## CONSULTATION ON PLANNING APPLICATION

App. No. 20190163  
Proposal: CONSTRUCTION OF THREE/FOUR STOREY BUILDING; 2 X RETAIL/CAFE SHOPS ON THE GROUND FLOOR (CLASS A1); 9 FLATS (6 X 1 BEDROOM) AND (3 X 2 BEDROOM) (CLASS C3)  
Location: CORNER OF CHURCH GATE & ST PETERS LANE  
PPRN: MML2386

**PLANNING APPLICATION: 20190163**

**Proposal: Construction of three/four storey building; 2 x retail/café shops on the ground floor and 9 flats**

Proposed First Floor Plan.  
Scale 1:100

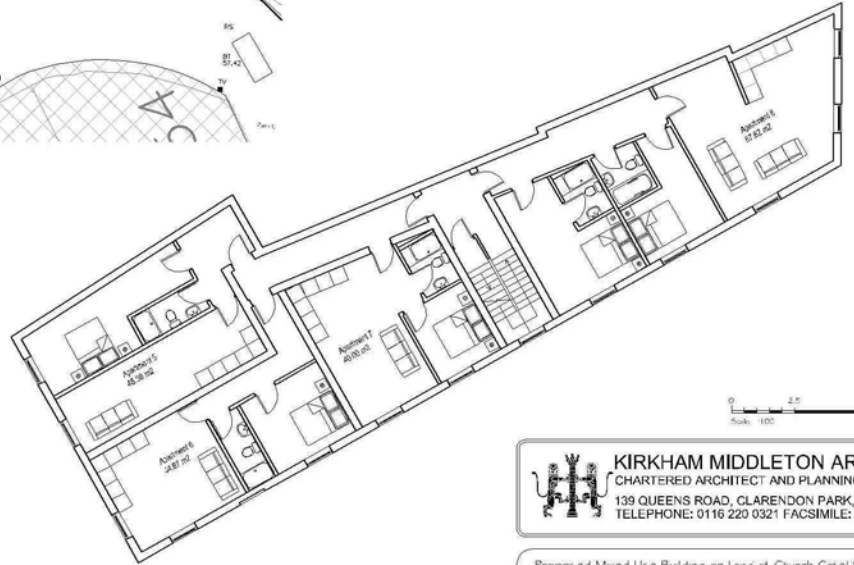
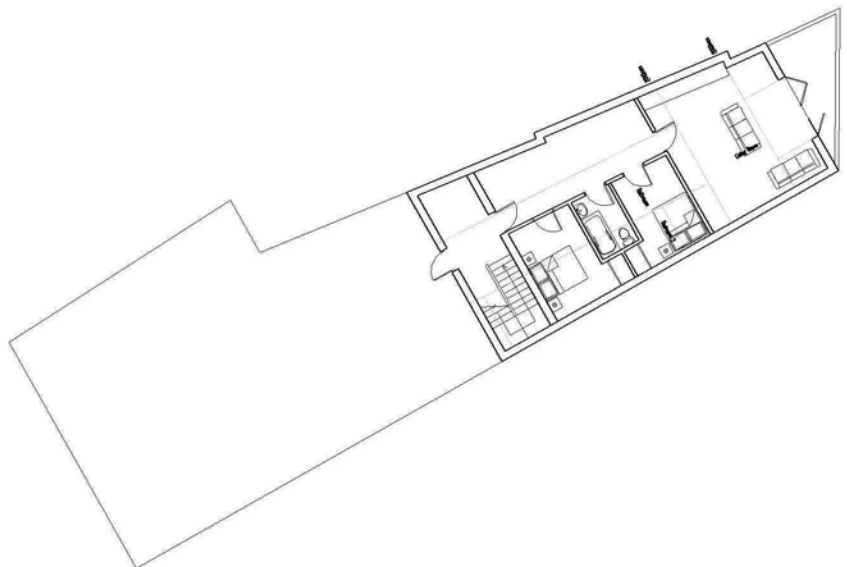
I would recommend that the noise insulation scheme is executed exactly as specified in the noise assessment ref: 2301 Leicester-Church Gate [Rev A] with particular emphasis on the recommendation to provide mechanical ventilation in habitable rooms overlooking St Peters Lane and Church Gate (Section 7.6 of Noise Assessment).

Proposed Side Elevation: Scale 1:100

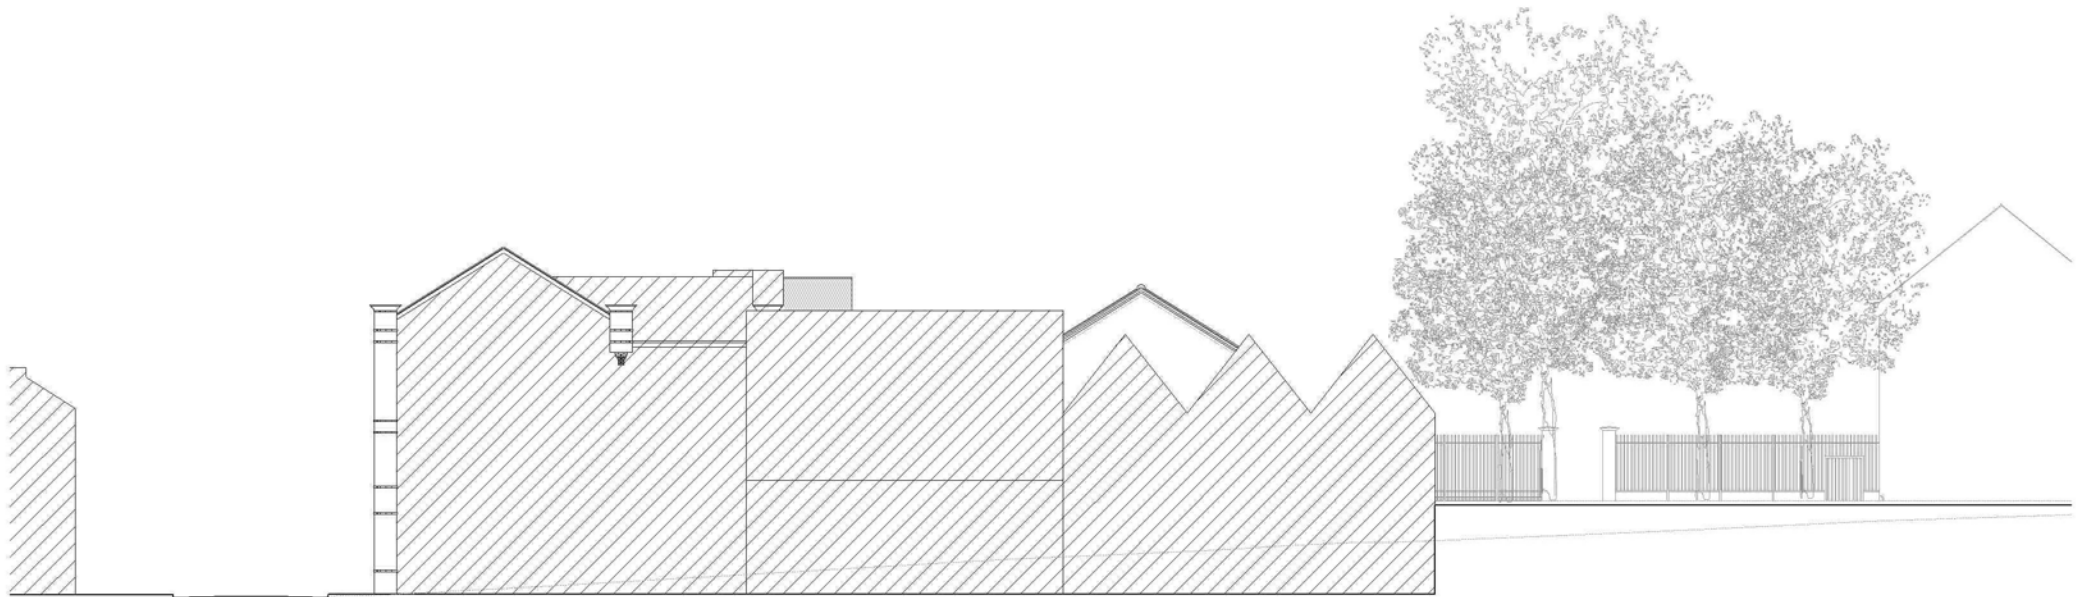
There is a visible disjunction between the Church Gate and St Peter's Lane façade as currently outlined. This is exaggerated by the differentiated material palette of these sections. Some features proposed for the Church Gate frontage are considered inappropriate, with special regards to the timber effect window units, directly associated with aluminium doors to the ground floor. The scheme broadly lacks consistency and displays a range of features of no precedence within the area, as the cedar cladding or the horizontal window unit to the west, and thus has the potential to detract from and harm the historic environment of Church Gate Conservation Area.

In addition, the lack of an active shopfront along St Peter's Lane is regrettable, not in line with the historic character of the area, largely dominated by commercial activity.
